Re: Sincox Lane, Shipley, West Sussex

Bellamy Roberts has been instructed by Forays Homes revise the surface and foul water drainage strategy with reference to the above scheme.

Enclosed:
Surface Water Drainage Strategy (6129/1003 rev. G)
Infodrainage Analysis
Drainage Construction Details (6440/1008 rev. A)

DATE	DRAWING No.	REV No.
07/08/24	6129 / 1003	G

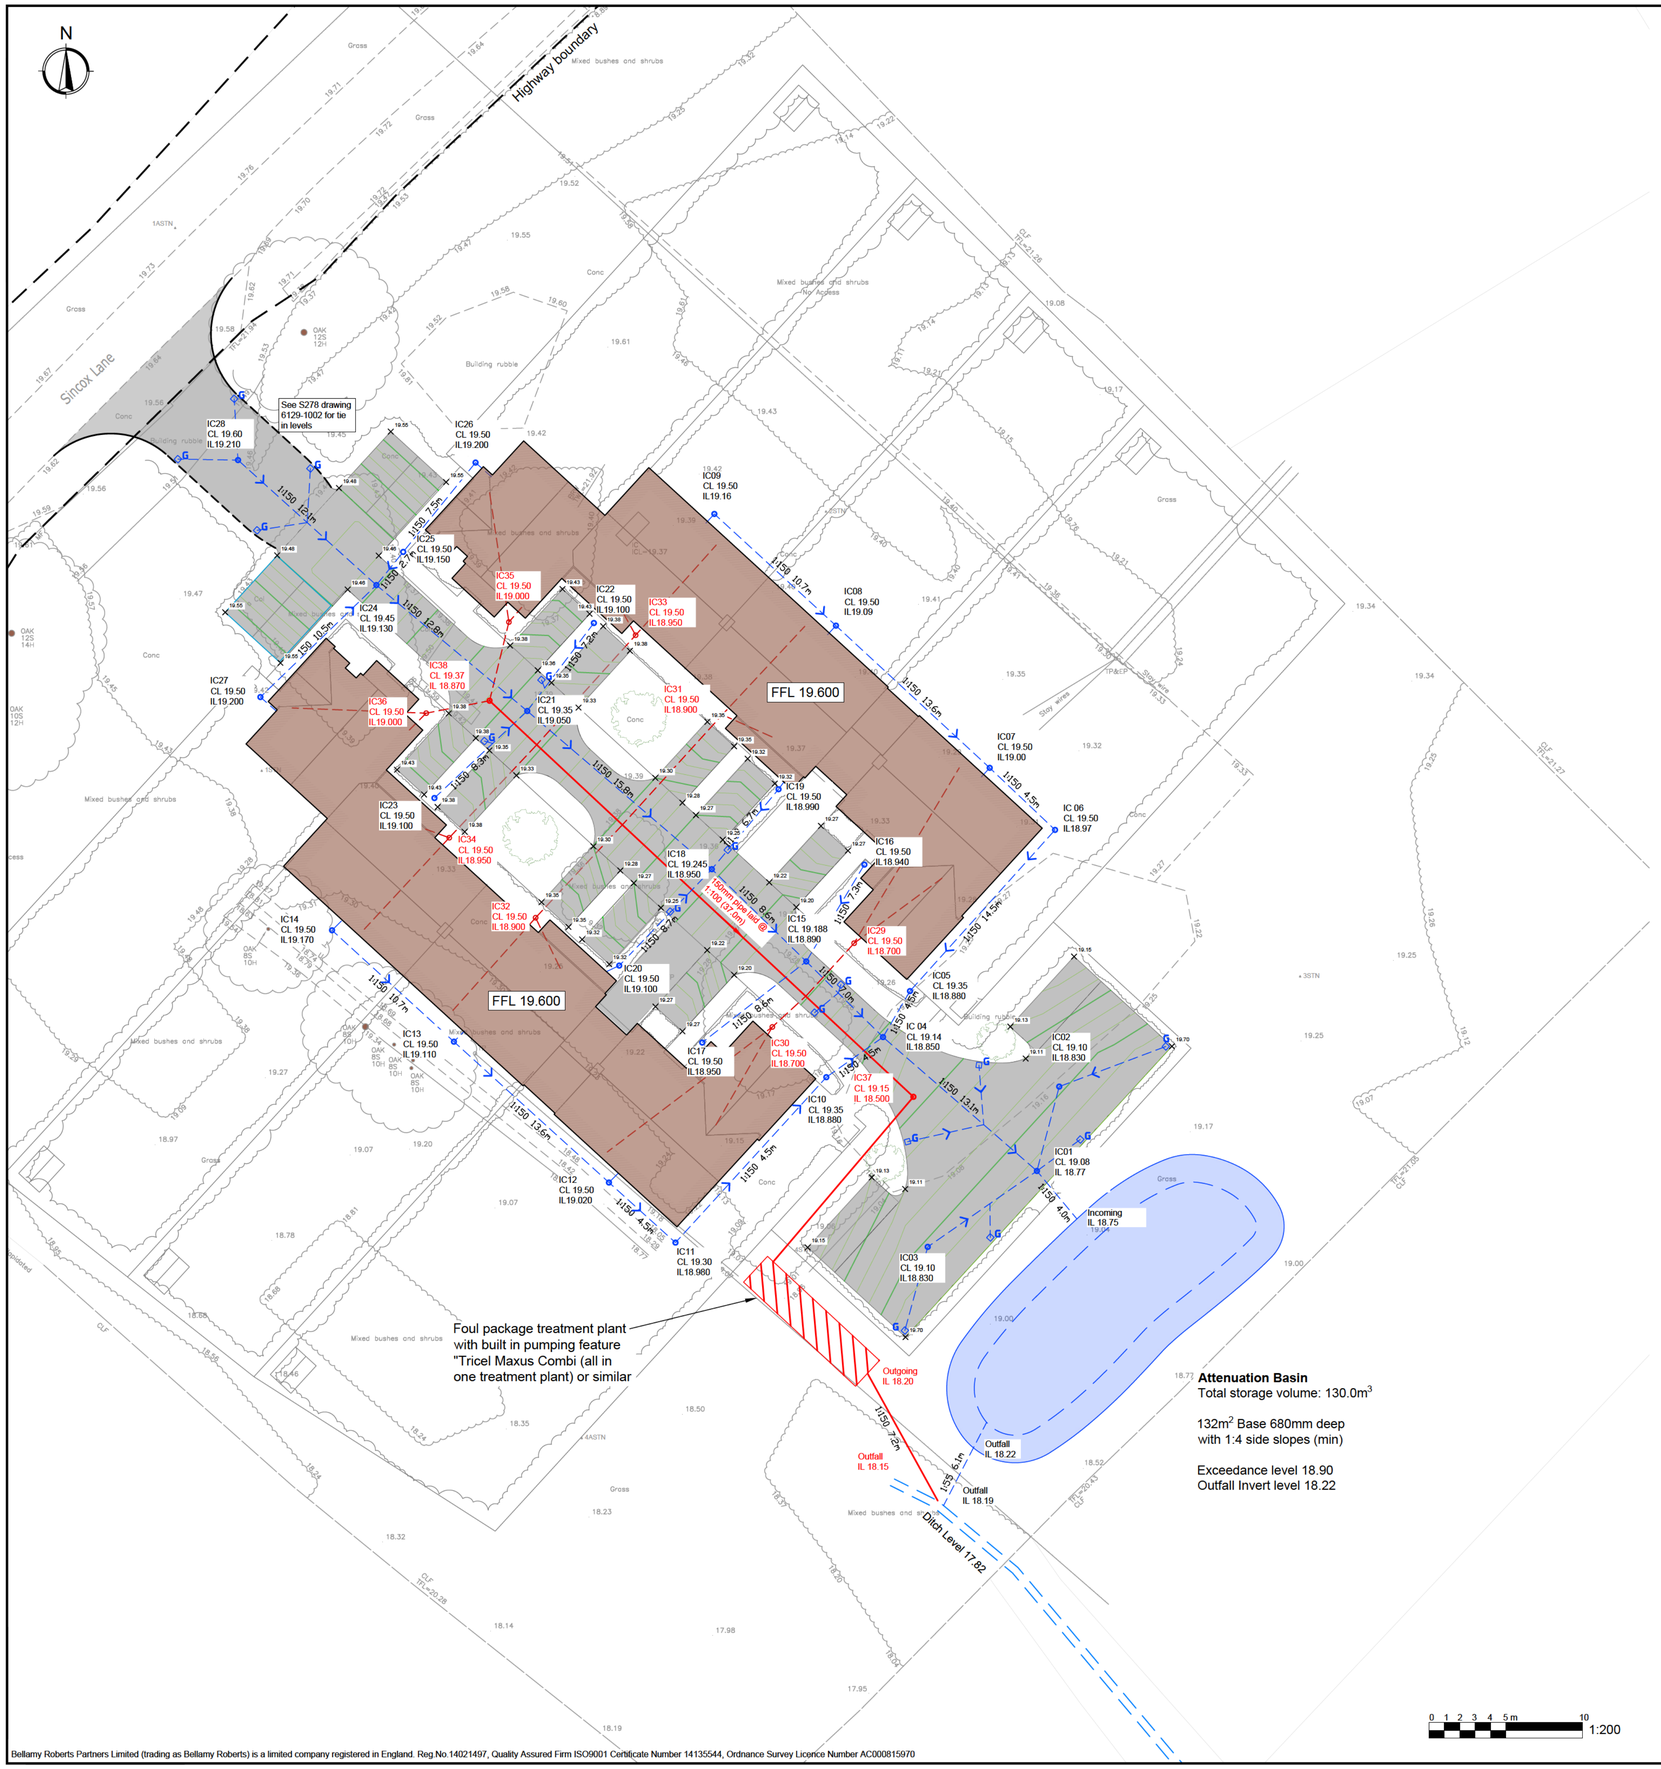
The previous land constraint issues have been resolved and the surface water strategy has been revised to incorporate an attenuation basin, rather than a cellular storage system. Outfall is still proposed to the ditch and the discharge rate remains at 1.1l/s.

The proposed package treatment plan has been relocated out of the proposed turning head.

Given above ground attenuation is preferable to below ground storage, it is considered that the revised strategy results in a betterment over that previously agreed.

Infiltration is expected to be extremely low on site due to results from a neighbouring site. A dry attenuation basin is being suggested with total storage capacity of 130m^3 to cater for 0.176ha of impermeable surface area, discharging at a maximum controlled rate of 1.1 l/s into a nearby ditch. Control orifice to be guarded to reduce risk of blockages.
